CLIENT:	NORTHSHORE CORPORATION	JOB NO.:	97-109
PROJECT:	NORTHSHORE LONG PLAT	ACAD FILE:	DRAIN2.DWG
TITLE:	DRAINAGE DETAILS	SHEET:	2
		OF:	2

SITE PLAN

REVISIONS:				DRAWN BY		DATE	CHECKED BY	DATE	SEAL:			HORIZONTAL SCALE: 1"=20'		CLIENT:	NORTHSHORE CORPORATION		JOB NO.:	97-109
1	CHANGES PER REDLINE COMMENTS FROM CITY OF FERNDALE			BDS		11/12/98						VERTICAL SCALE:	DRAWN BY:	PROJECT:	NORTHSHORE LONG PLAT		ACAD FILE:	DRAIN1.DWG
2	CHANGES PER REDLINE COMMENTS FROM CITY OF FERNDALE			BDS		12/11/98						DATE:	APPROVED BY:	TITLE:	DRAINAGE PLAN		SHEET:	1
3												NORTH ROTATION:					OF:	2

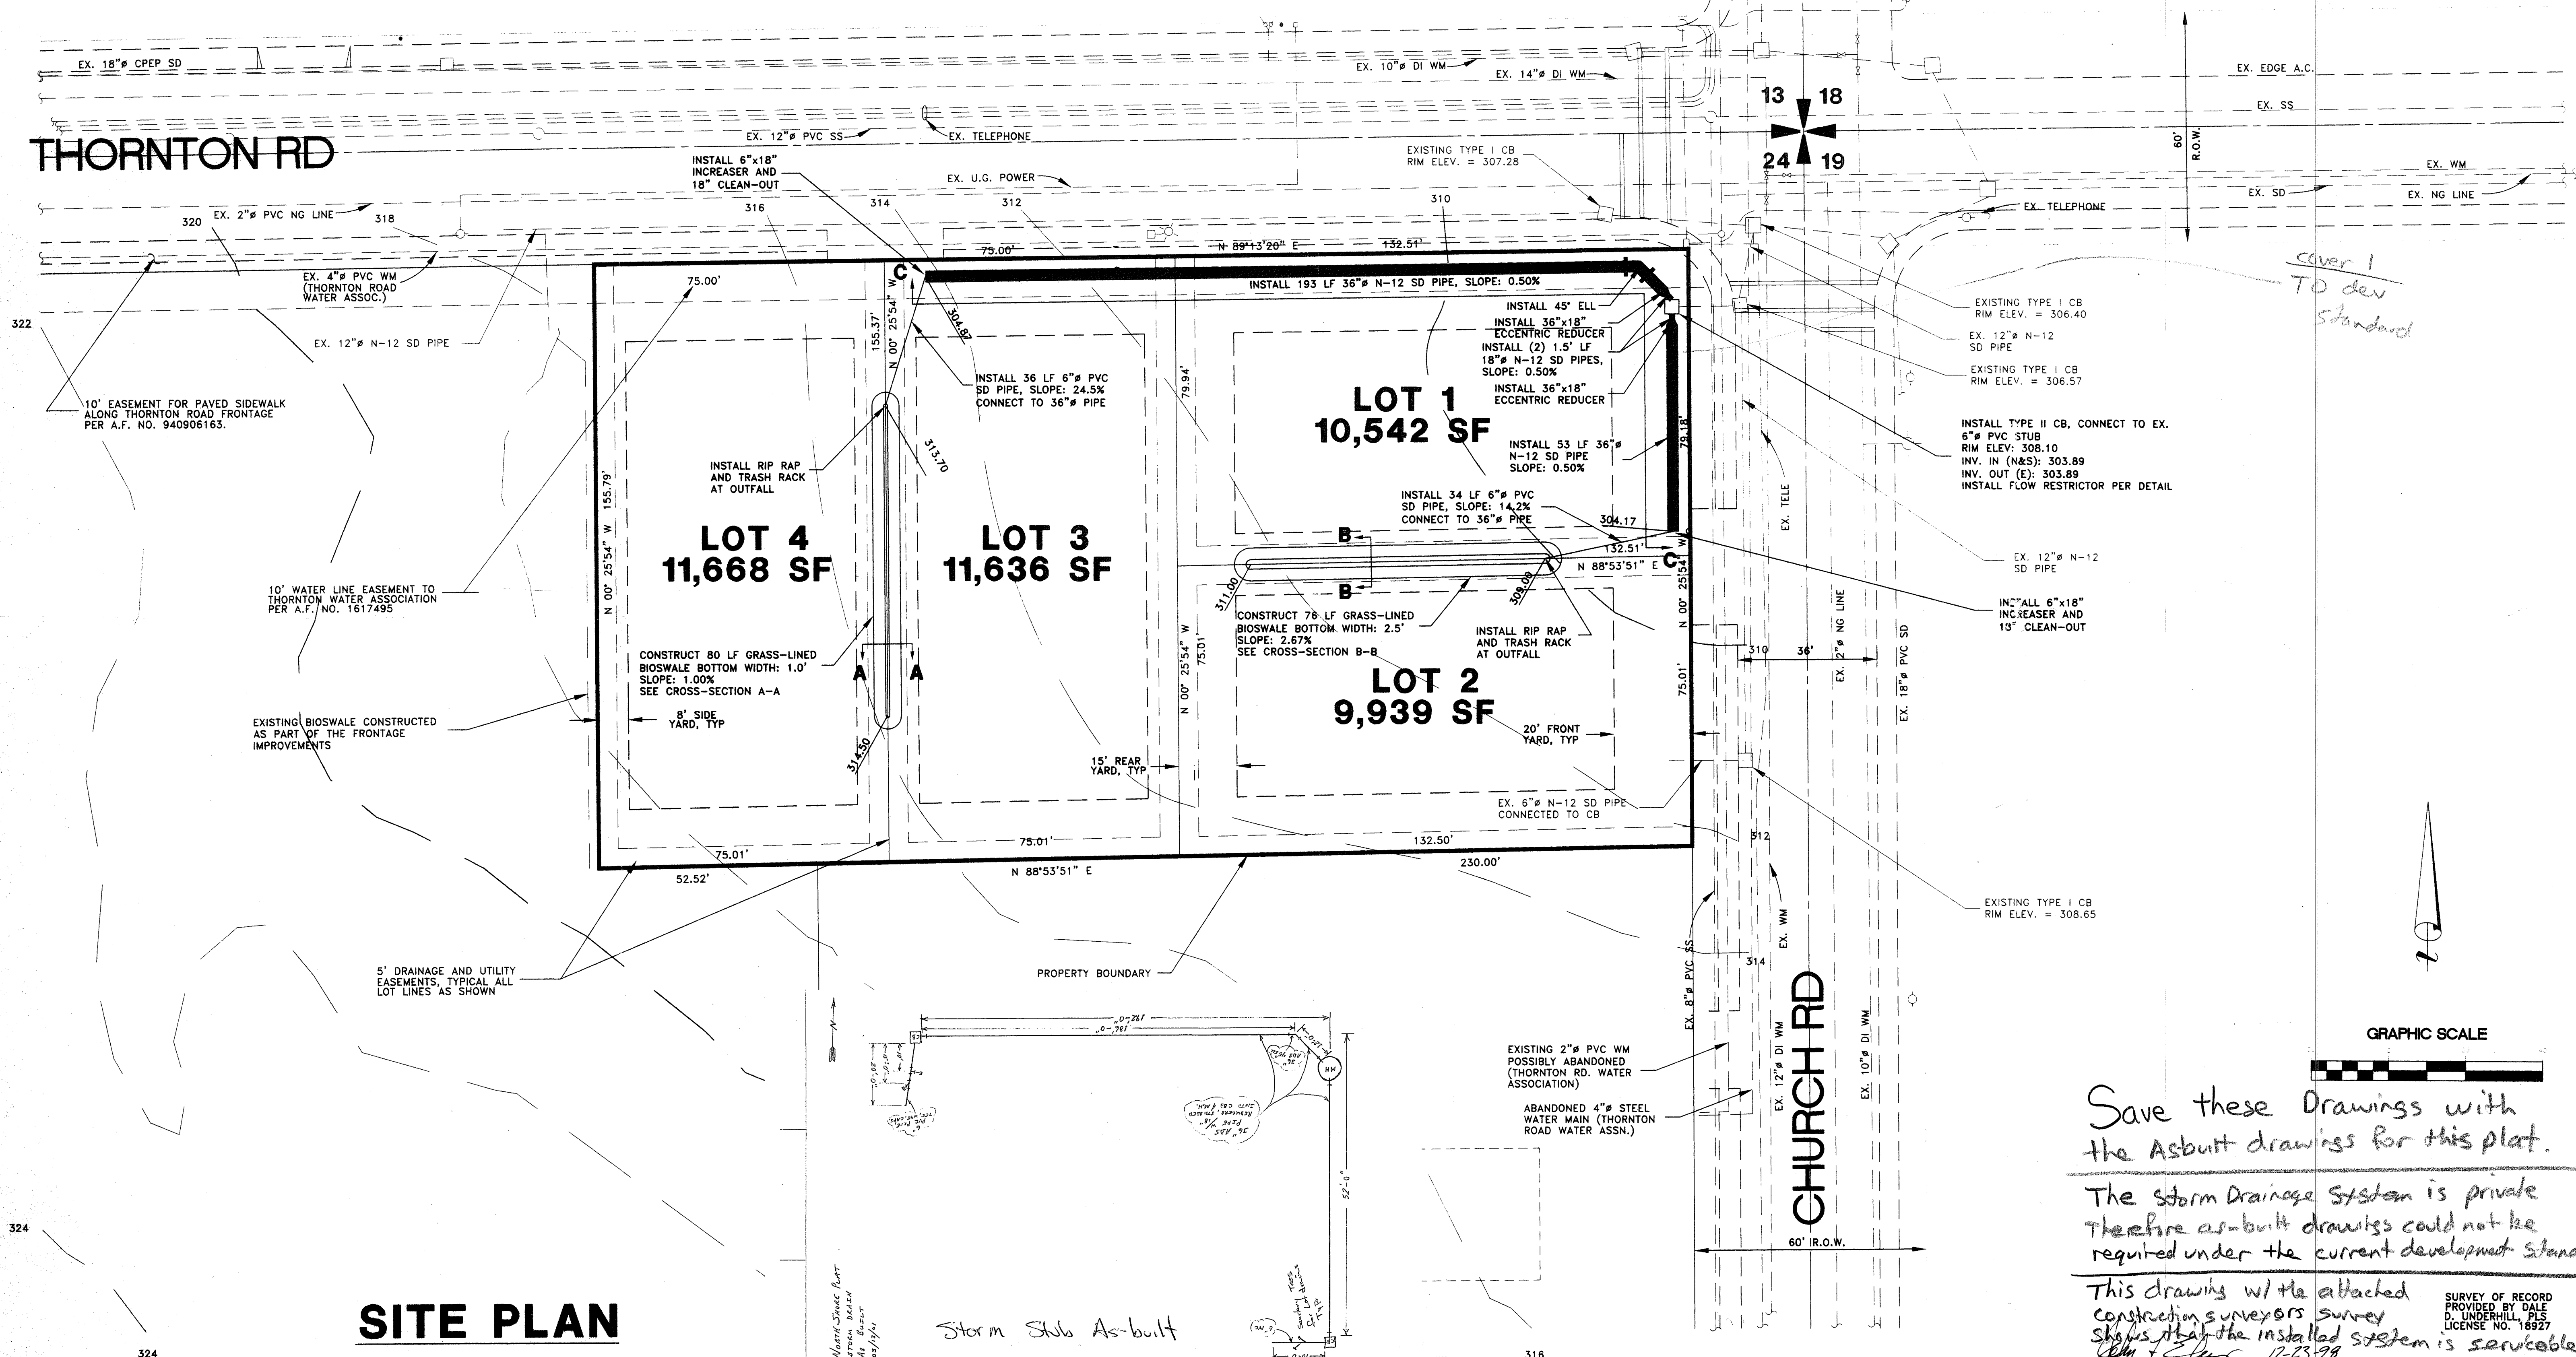
Private Storm System

Save these Drawings with the Asbuilt drawings for this plat.

The storm Drainage System is private Therefore as-built drawings could not be required under the current development standard.

This drawings w/ the attached construction surveyors survey shows that the installed system is serviceable.
